# **42/50G2 PDP modules vertical line issue repair method**

2009. 7. 09

**HE Company / LGERS / Design Gr.**

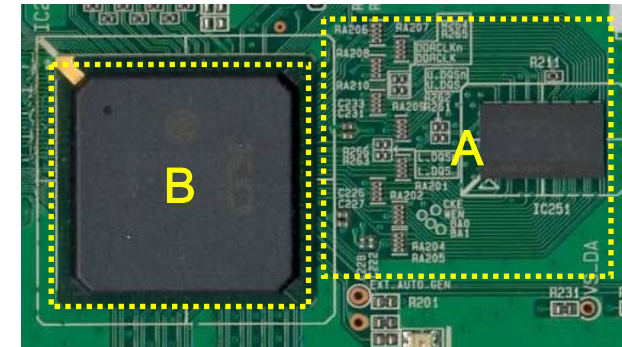
This problem is mostly related to failure in DQ signal paths from DDR2 memory IC251 to BGA IC201.

A. Check the components solder quality, foils and via holes integrity.

B. Press BGA IC firmly to check for bad solder.

Refer to A1 figure in page 5.

#### Check points

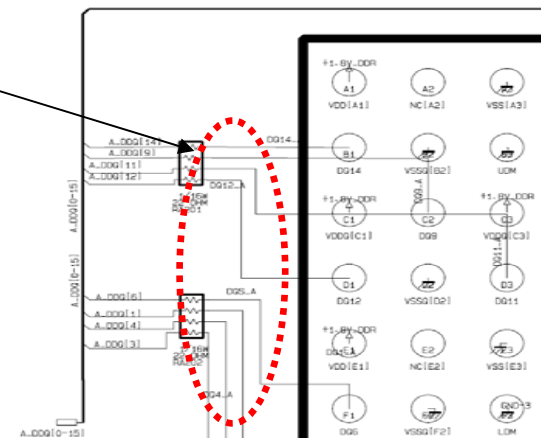
C. Check diode value of the 16 DQ lines using multi-meter, GND(+)-to-DQ line(-) (refer to A3 picture in the last slide)  
Normal diode voltage drop is (0.4 to 0.5 Vdc).

If everything is OK and failure persist, change the control board assy.

### 2. Vertical line without same interval (8pixels, 16pixels or 32pixels).

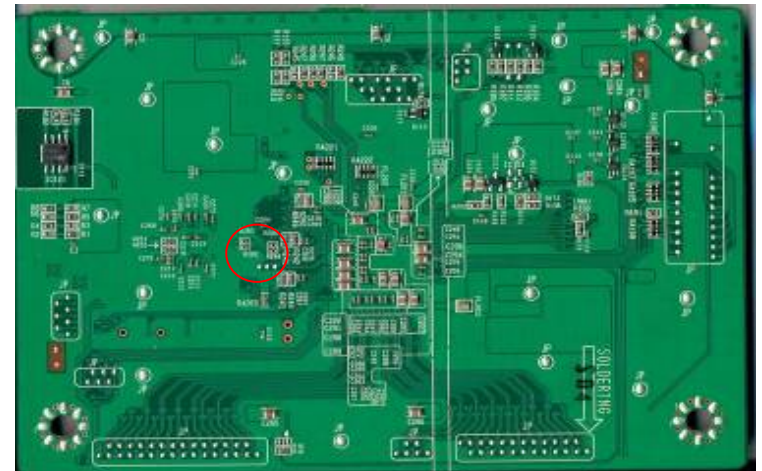
- A. Check the control board DQS Resistors coming out from DDR memory to BGA IC (backside R282 , R283 , R284 , R285)

- DQS (local clock function) resistor value must be  $470\Omega$ .

-  $1k\Omega$  has some potential probability to cause vertical lane when repeatedly connected and disconnect of LVDS cable.

- B. Check diode value of the 4 DQS lines.  
(refer to A3 picture in the last slide).  
Normal diode voltage drop is (0.4 to 0.5 Vdc).

If  $1K\Omega$  resistor value is found, change to  $470\Omega$  ( $1k\Omega \rightarrow 470\Omega$ ).

If everything is OK and failure persist, change the control board assy.

# A1. Vertical Noise Failure cause

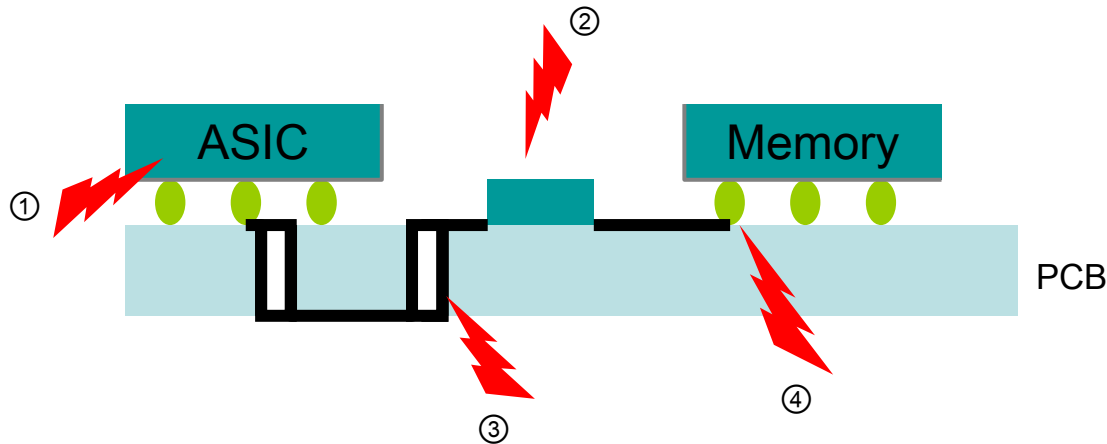
## Possible Failure Cause of Picture (Vertical) Noise upon DDR Memory

- ① Pin fail : Diode check with multi-meter.
- ② Resistor Crack and soldering problem : visual inspection
- ③ Via hole crack : Diode check, resistor check visually and using multi-meter.
- ④ Ball crack and soldering problem in BGA IC's: Press devices toward PCB
